UNITED STATES PATENT AND TRADEMARK OFFICE

APPLICATION NO.	FILING DATE	FIRST NAMED INVENTOR	ATTORNEY DOCKET NO.	CONFIRMATION NO.
09/374,681	09/19/2002	CRAIG H. BAKER	81762/210	4027

Office Action Summary

DETAILED ACTION

ATTACHMENT

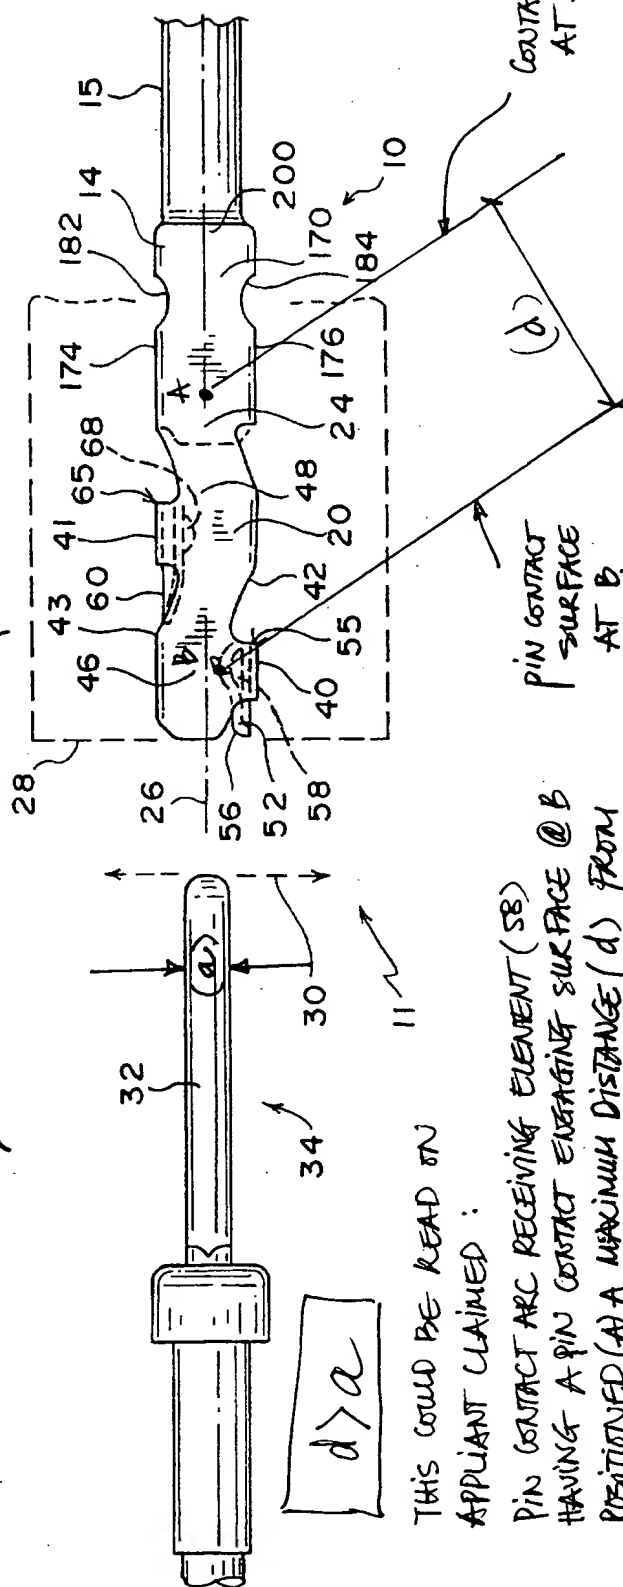
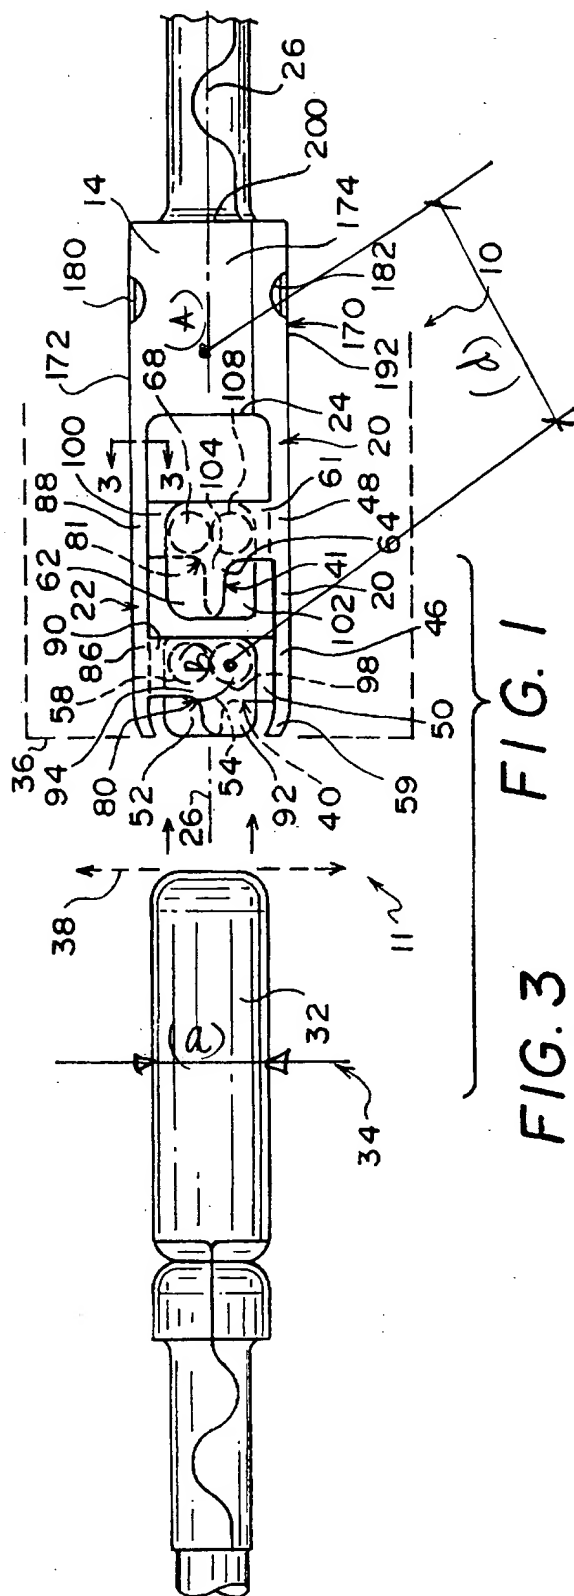
WATERKIN (d) IS NOT PERPENDICULAR TO (26)

PIN CONTACT ARC RECEIVING ELEMENT (SB)
HAVING A PIN CONTACT ENGAGING SURFACE @ B
POSITIONED (A) A MAXIMUM DISTANCE (d) FROM
(B) AT THE SOCKET CONTACT BORE AXIS (26) IS
GREATER THAN THE MAXIMUM TRANSVERSE
DIMENSION OF PIN CONTACT (34)

THIS COULD BE READ ON
APPLICANT CLAIMED :

$d > a$
